# Access Compliance Report

## Public Rights-of-Way

### (Curb Ramps)

Intersection ID: 6933	Main Street: OAKDALE_RD	Cross Street: OLD_PLANK_RD	Location: NE
ADA ID: CE6972003068	Ramp Type: Perp	Initial Pass/Fail: Fail	Overall Compliance: No
			Severity Score: 13.75

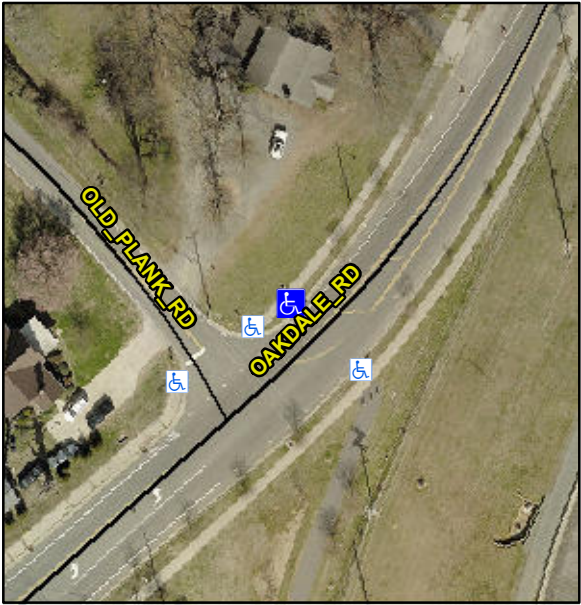
Codes/Mitigation Info/Possible Solution		Field Measurements/Component Compliance			
	Possible Solutions:				
	Remove & Replace Entire Ramp.				
	Surveyor Notes:				
	N/A				
	PROW/ADA:				
	Not Found, R304.2.2, R304.5.3				
Street 1 Name	OAKDALE RD				
Stop Condition-Street 2	None				
Street 2 Name	N/A				
Stop Condition-Street 1	N/A				
	Total Cost:	\$	1850.00

Compliance	Description	Data	Compliance	Description	Data
N/A	Ramp Length (in)	51.0	No	Ramp Slope (%)	8.5
Yes	Ramp Width (in)	83.0	No	Ramp XSlope (%)	3.0
N/A	Flare Type LT	N/A	N/A	Flare Type RT	N/A
N/A	Flare Slope LT (%)	N/A	N/A	Flare Slope RT (%)	N/A
N/A	Flare Traversable LT?	N/A	N/A	Flare Traversable RT?	N/A
N/A	Landing Length (in)	N/A	N/A	DWS Provided?	N/A
N/A	Landing Width (in)	N/A	N/A	DWS Contrast?	N/A
N/A	Landing Slope (%)	N/A	N/A	DWS Length (in)	N/A
N/A	Landing X Slope (%)	N/A	N/A	DWS Full Width?	N/A
N/A	Landing Curb? (Y/N)	N/A	N/A	DWS Offset (in)	N/A
N/A	Shared Landing?	N/A			
N/A	Gutter Ponding?	N/A	N/A	Gutter Slope (%)	N/A
N/A	Gutter Lip Ht (in)	N/A	N/A	Gutter X Slope (%)	N/A
N/A	Painted X Walk1?	No	N/A	Painted X Walk2?	N/A
	X Walk 1 Direction	To SE		X Walk 2 Direction	N/A
N/A	X Walk 1 Width (in)	N/A	N/A	X Walk 2 Width (in)	N/A
	X Walk 1 Slope (%)	0.4		X Walk 2 Slope (%)	N/A
	X Walk 1 X Slope (%)	2.1		X Walk 2 X Slope (%)	N/A
